Our Ref L.448.033.EE

Proposal: Application under Section 96a of the Town and County Planning Act 1990 (as amended) to make non-material amendments to permission 200188 (allowed on appeal under APP/E0345/W/21/3276463 on 17/03/2022) for Demolition of existing structures and erection of a series of buildings ranging in height from 1 to 11 storeys, including residential dwellings (C3 use class) and retail floorspace (A3 use class), together with a new north-south pedestrian link, connecting Christchurch Bridge to Vastern Road), including an increase from 4 to 5 storeys of the western wing of Block B, amendments to the top two floors of Blocks D & E, changes to the unit mix and various other associated alterations (amended description) as approved under App. Ref. 231673 (from 27th March 2024), to amend the drawings listed under condition 47.

Location: 55 Vastern Road, Reading, RG1 8BU.

Approved drawings
vs.
now proposed drawings

Block B and C - MVHR Proposal
Glazing and Ventilation Plans

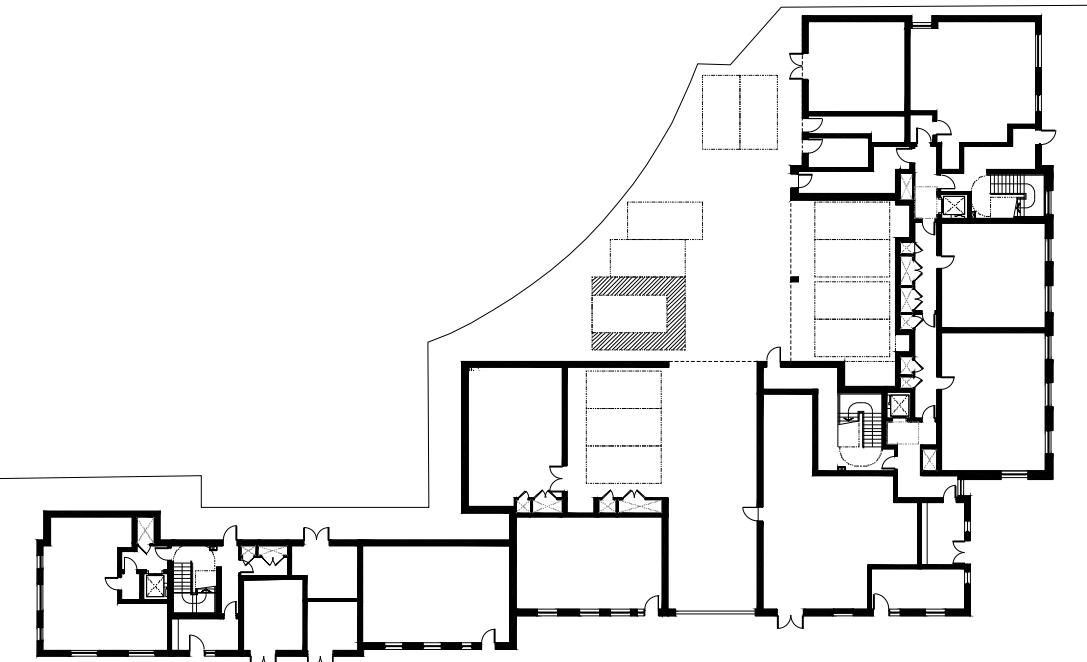
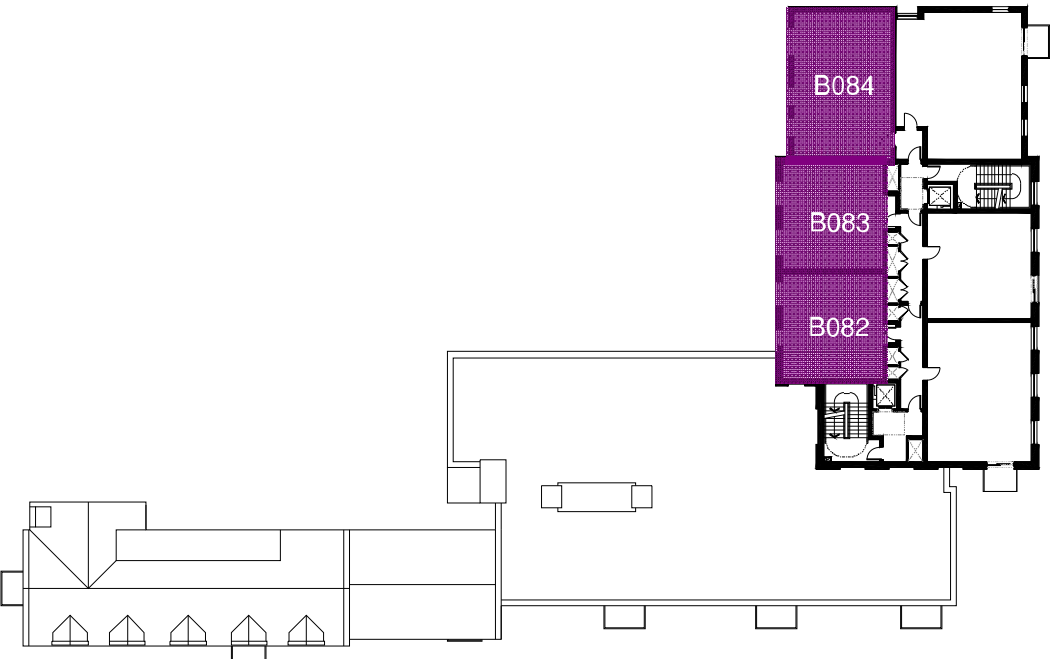
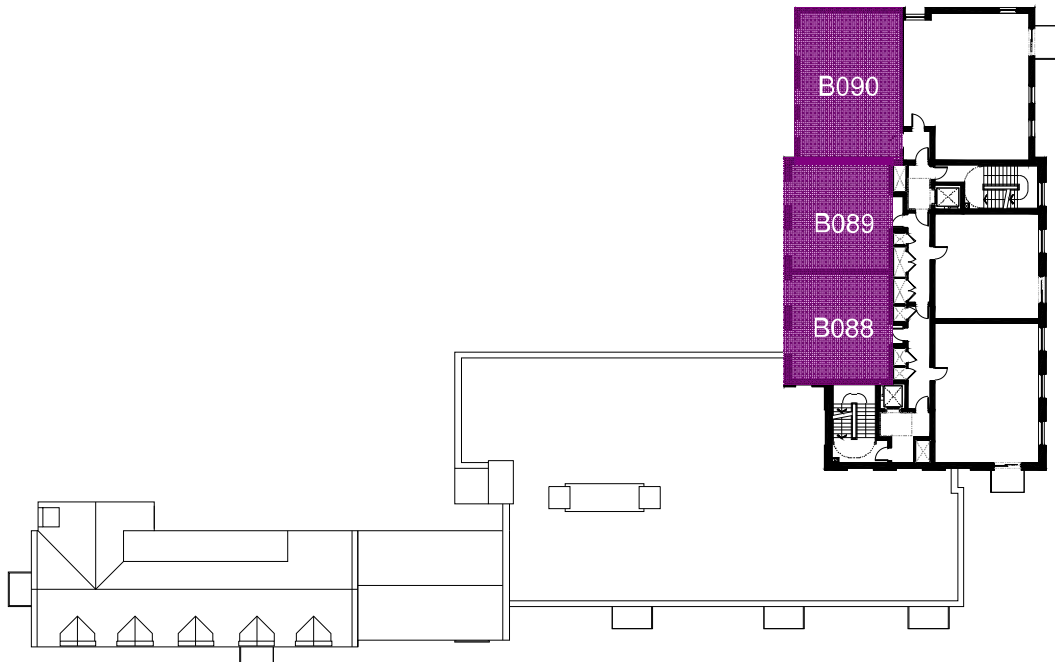
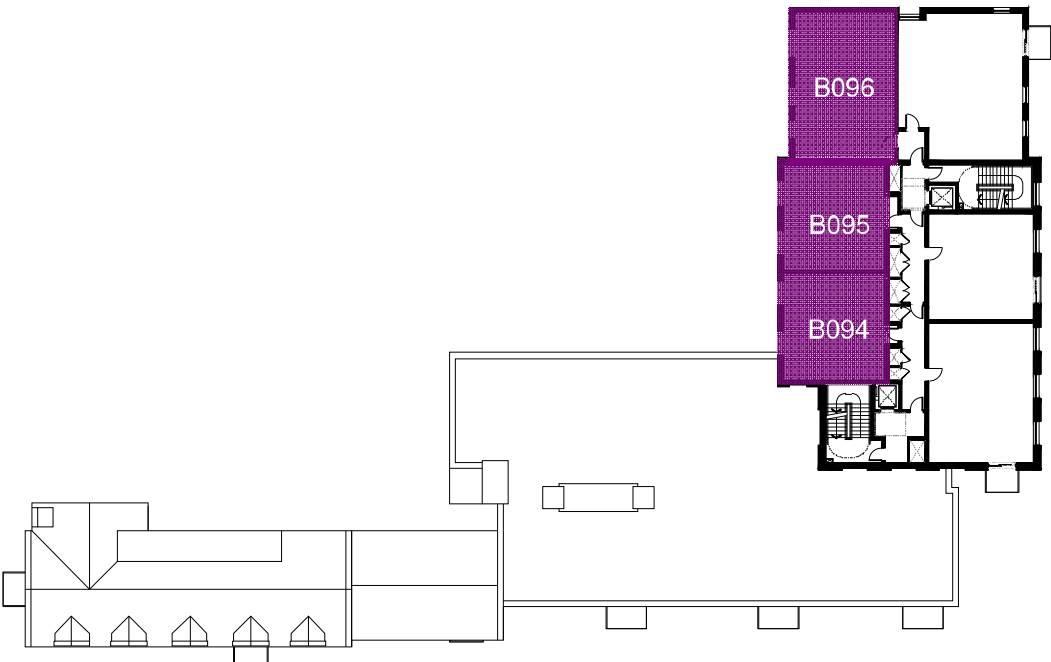
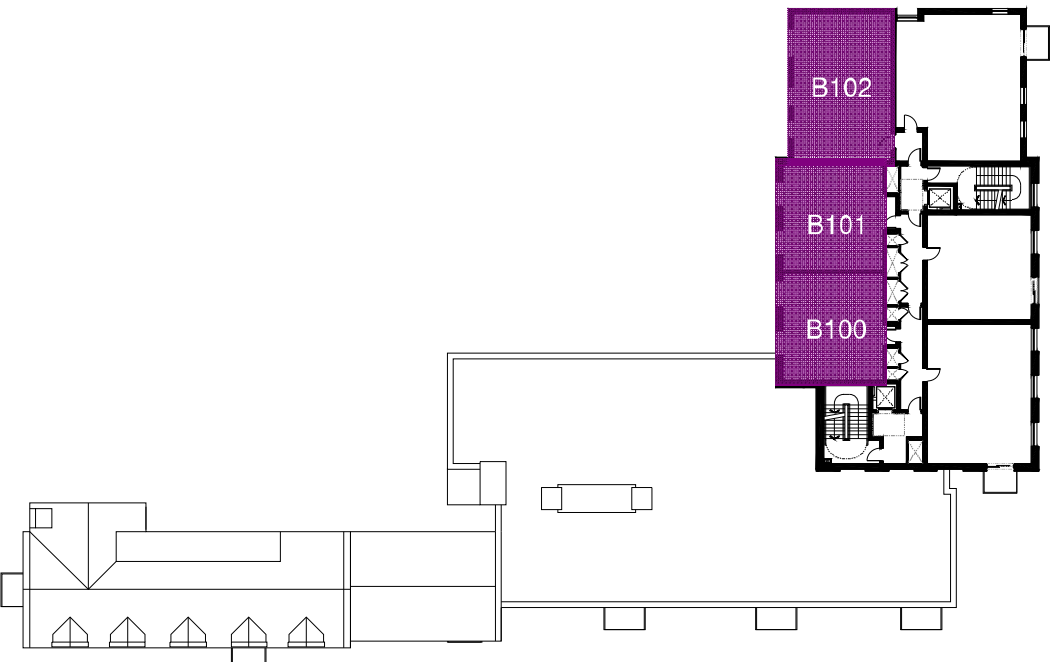
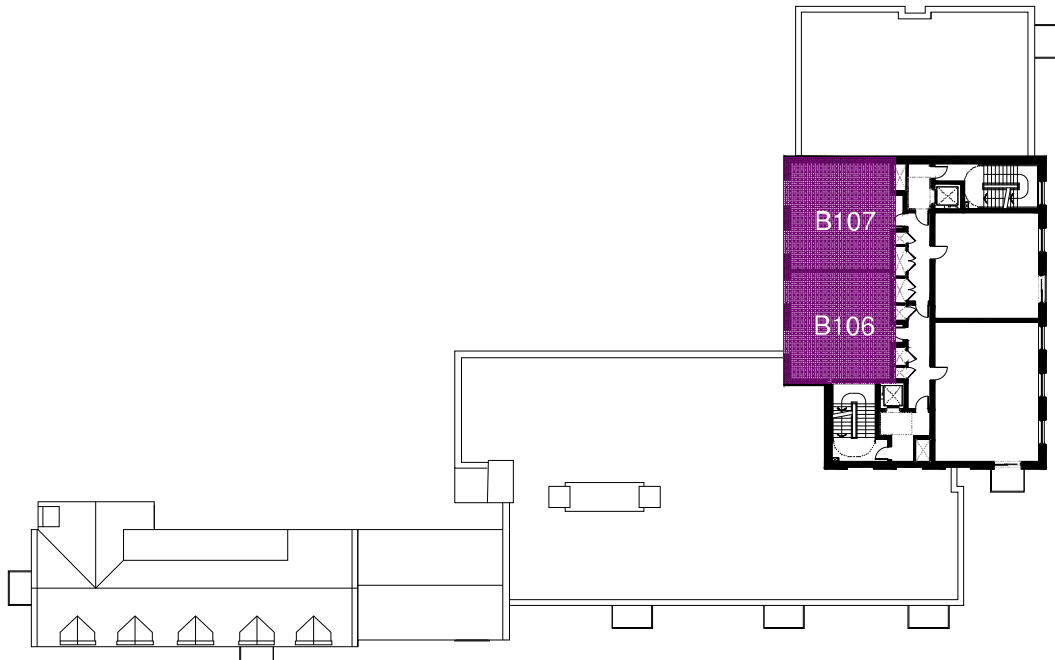
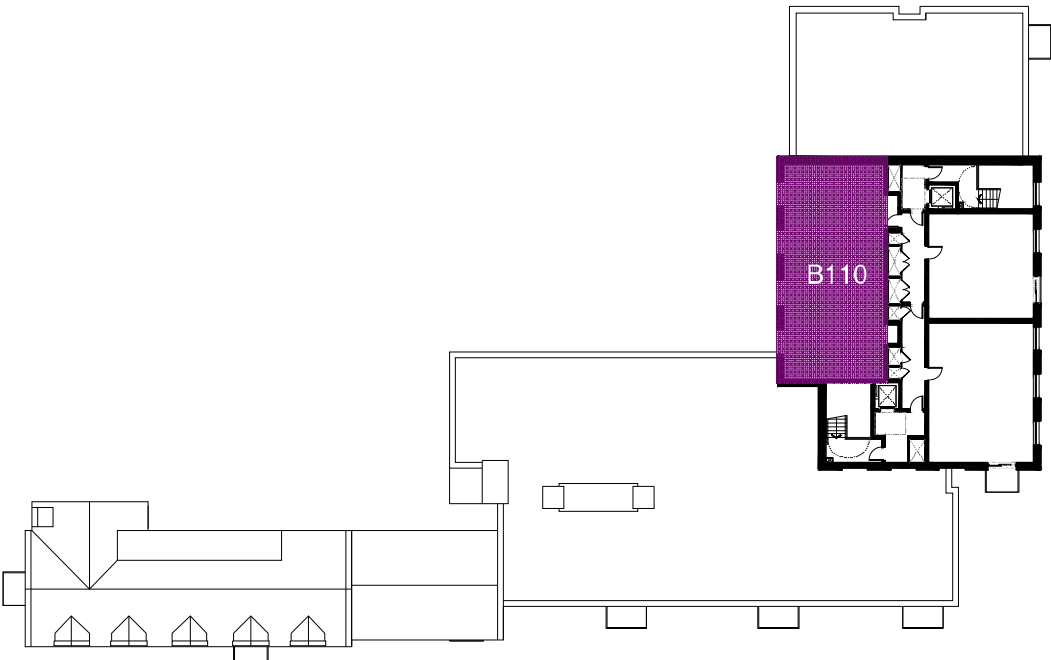
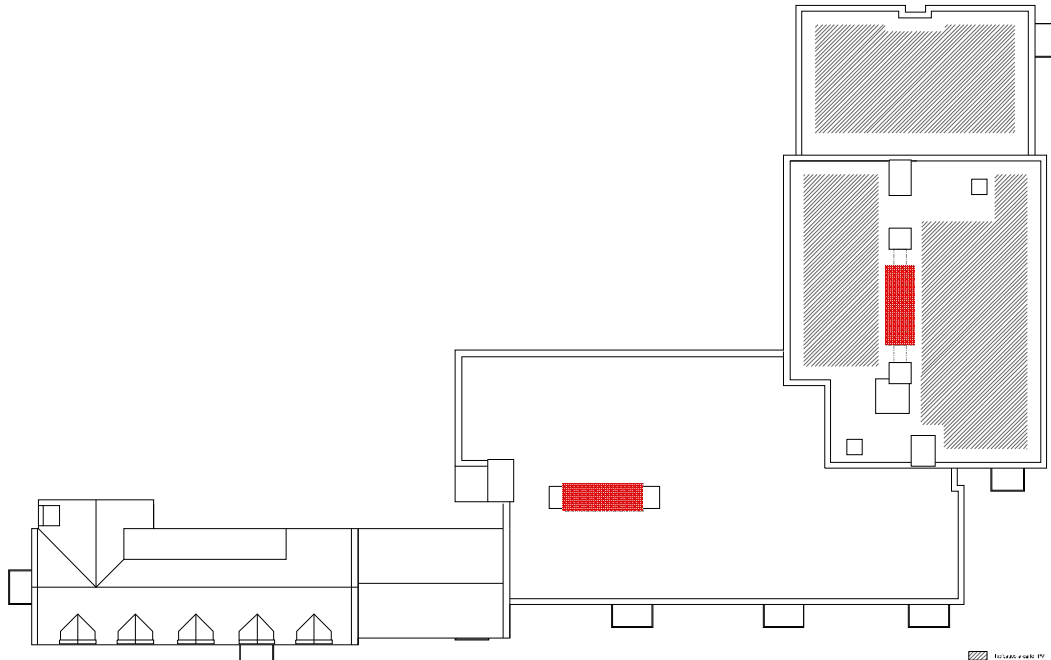
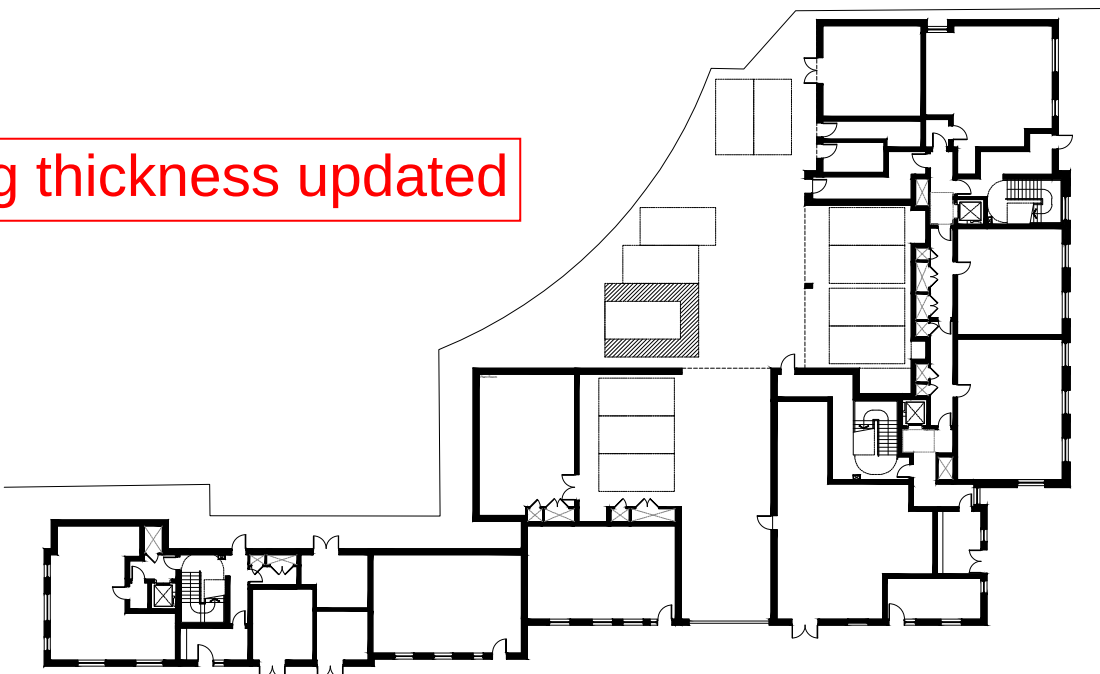
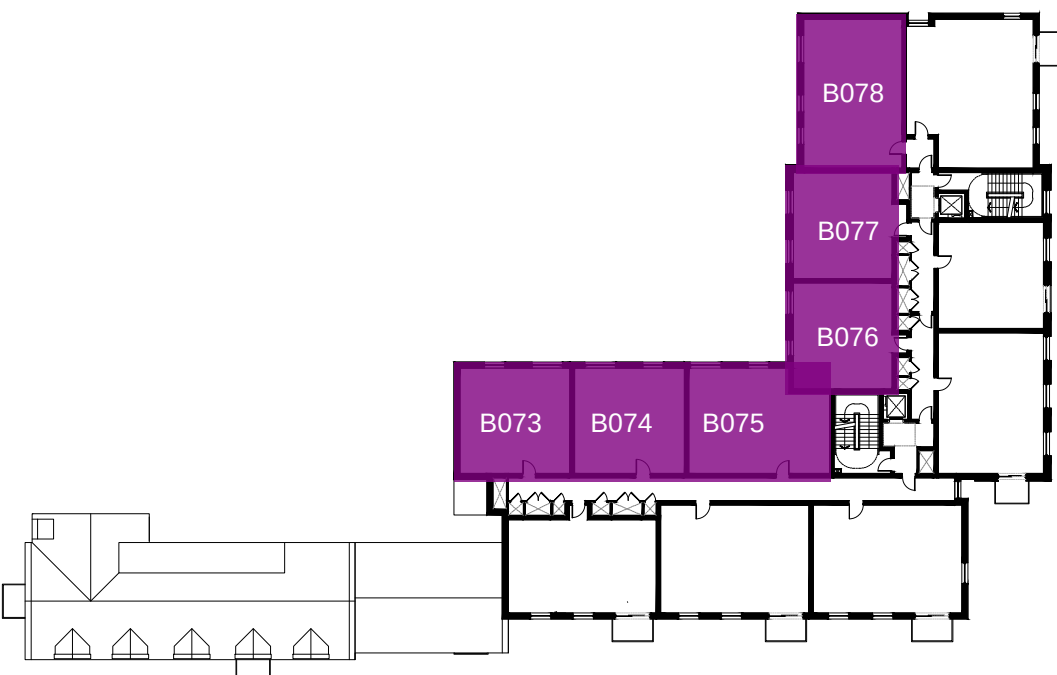
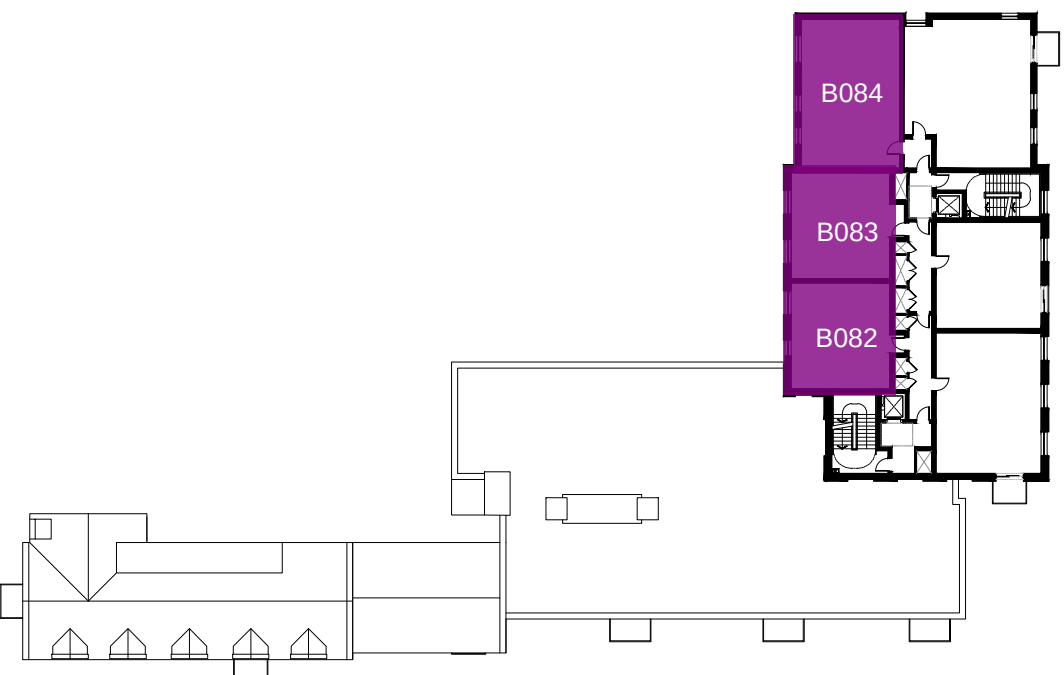
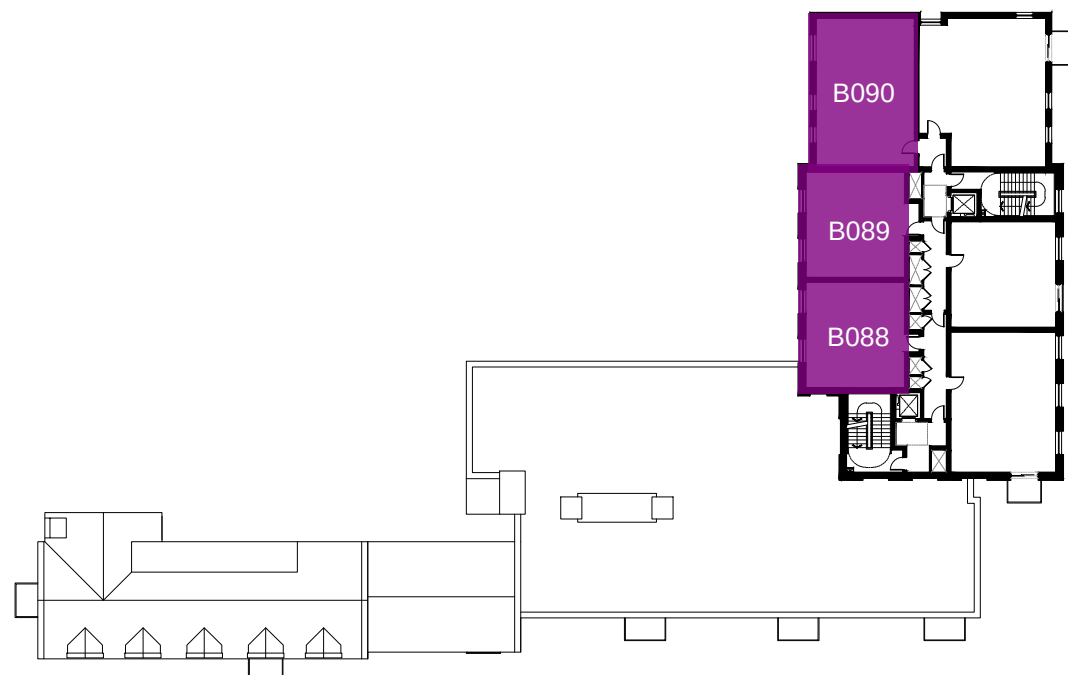
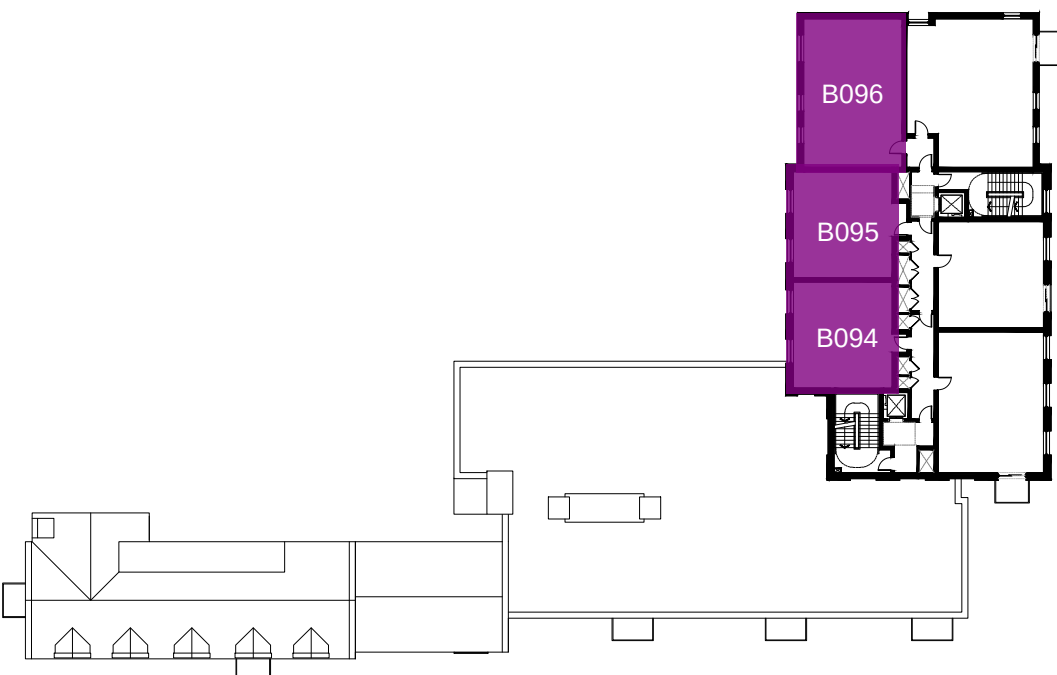
Triple Glazing:
9.5mm glass - 6mm airgap - 4mm glass -14mm airgap - 4mm glass
Secondary Glazing:
200mm airgap - 8.8mm acoustic laminated glass
Ventilation:
All atmospheric termination on the roof.
No atmospheric termination on the facade.

Triple Glazing:
9.5mm glass - 6mm airgap - 4mm glass -14mm airgap - 4mm glass
Secondary Glazing:
200mm airgap 6mm acoustic laminated glass
Ventilation:
No atmospheric termination on the roof.
All atmospheric termination on the facade.

Glazing thickness updated

roof equipment omitted
as not required

Drawing Name	Approved drawing reference:	Changing to:	Amendment
Block B and C			
MVHR Proposal Glazing and Ventilation Plans	448.PL.BC.V.100.B	448.PL.BC.V.100.C	Glazing thickness updated in line with the report R10314-22 Rev 0
MVHR Proposal First Floor Plan	448.PL.BC.V.101.B	448.PL.BC.V.101.C	Ventilation ducting updated.
MVHR Proposal Second Floor Plan	448.PL.BC.V.102.B	448.PL.BC.V.102.C	Ventilation ducting updated.
MVHR Proposal Third Floor Plan	448.PL.BC.V.103.B	448.PL.BC.V.103.C	Ventilation ducting updated.
MVHR Proposal Fourth Floor Plan	448.PL.BC.V.104.B	448.PL.BC.V.104.C	Ventilation ducting updated.
MVHR Proposal Fifth Floor Plan	448.PL.BC.V.105.B	448.PL.BC.V.105.C	Ventilation ducting updated.
MVHR Proposal Sixth Floor Plan	448.PL.BC.V.106.B	448.PL.BC.V.106.C	Ventilation ducting updated.
MVHR Proposal Seventh Floor Plan	448.PL.BC.V.107.B	448.PL.BC.V.107.C	Ventilation ducting updated.
MVHR Proposal Eighth Floor Plan	448.PL.BC.V.108.B	448.PL.BC.V.108.C	Ventilation ducting updated.
